***PLANNING REPORT ON THE LITIGATION
SETTLEMENT AGREEMENT OF TMB
PARTNERS, LLC AND THE TOWNSHIP OF
LIVINGSTON***
BLOCK 7001, LOT 1

LIVINGSTON TOWNSHIP
Essex County, New Jersey

Prepared January 20, 2009 for

MILLBURN TOWNSHIP

Figure 2

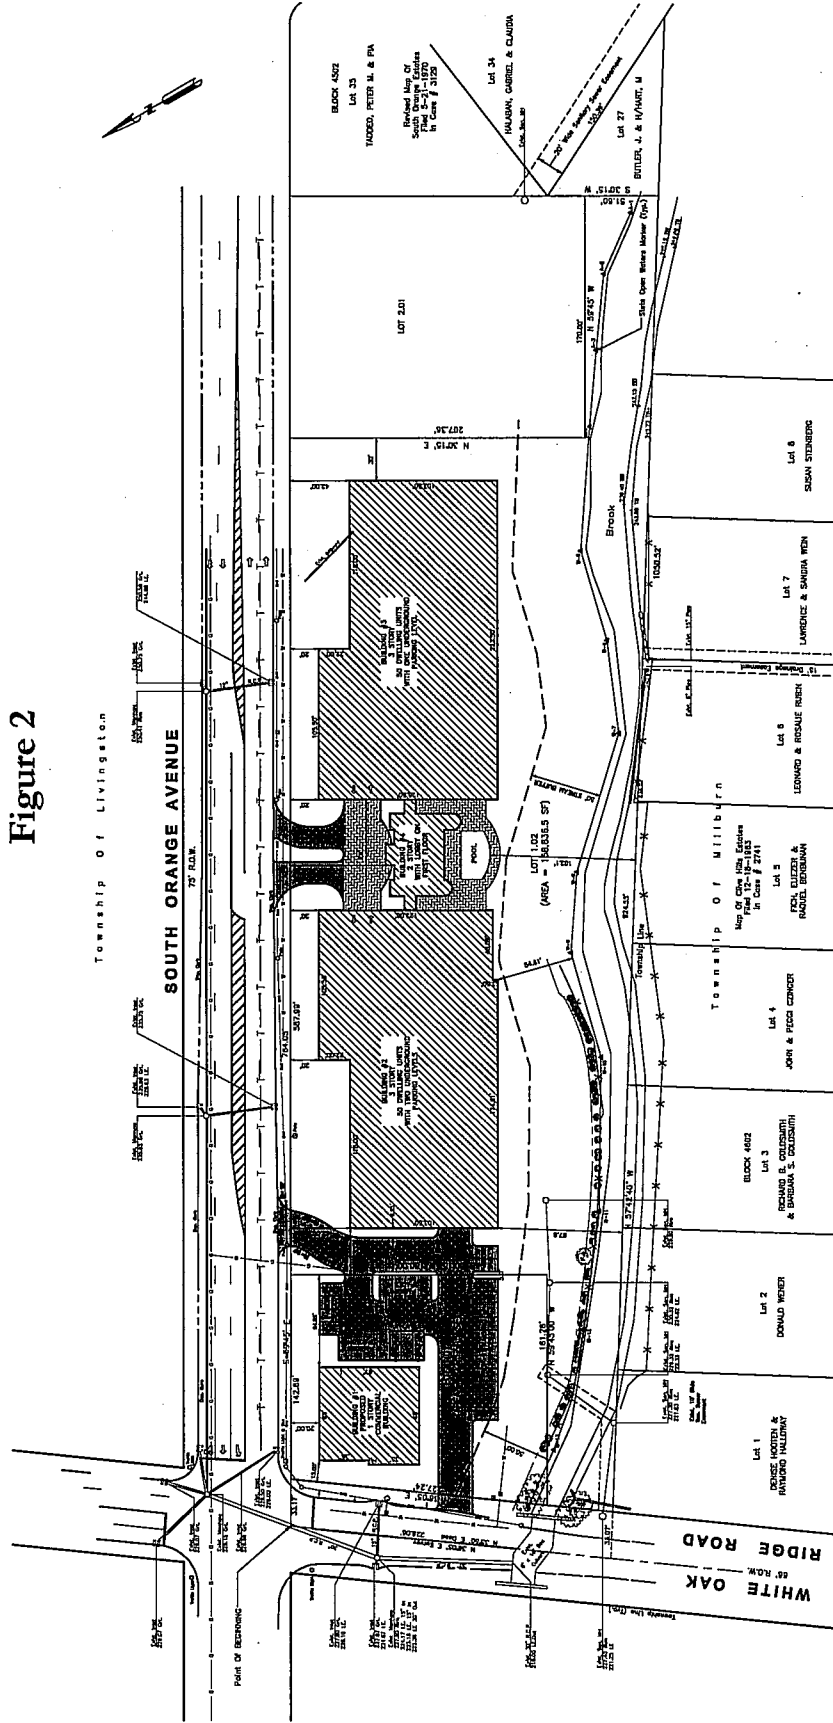
- A 50-foot stream encroachment buffer is shown on the concept plans to protect the Canoe Brook. This planning analysis recognizes that a 50-foot buffer is the “smallest” buffer that may be considered by the NJDEP adjacent to waterways. If the 50-foot buffer is approved by NJDEP, the majority of on-site open space would be unusable for active recreation purposes. Moreover, we note that a portion of the entrance driveway from White Oak Road is located within the 50-foot stream buffer area (See Figure 2). The lack of usable active open space for the ±200 residents who would live at the proposed development is an indication of the overutilization of the site and an indication as to why the site is unsuitable for a proposed gross density of 23.81 units per acre. Furthermore, the planting of an evergreen buffer may not be permitted for unimproved areas of the subject property located within the 50-foot stream buffer area, which would prevent adequate screening of the proposed 223-foot long 73-foot tall buildings to the adjoining single-family homes in Millburn Township.

7. The proposed development is dependent upon the inclusion of one to two levels of below grade parking. The inclusion of below grade parking in single-family residential districts is most unusual. Moreover, we question the wisdom of locating below grade parking adjacent to a stream corridor.

9. The proposed development will negatively impact adjoining single-family residents in Millburn Township. The construction of 100 apartments within 73-foot tall 223-foot long buildings adjacent to single-family homes less than 35 feet in height is too intensive given the existing context and character of the area. In fact, Ms. McKenzie herself acknowledges on page 5 of her report that "the development proposed for the site is fairly intense for the area (approximately 23 units per acre), and it will introduce buildings up to four stories (65 feet) in an area where the predominant building height is 2½ stories." Further, reduced setback and bulk requirements (i.e., as compared to other affordable housing districts in Livingston) are inappropriate given the proposed building heights and the site's proximity to an established single-family residential neighborhood. Finally, the proposed 50-foot stream encroachment buffer renders it difficult if not impossible to construct a suitable buffer within unimproved areas of the site. The inability to create an appropriate landscaped buffer will most negatively impact residents along the Rippling Brook Drive cul-de-sac in Millburn Township (See Figure 3).
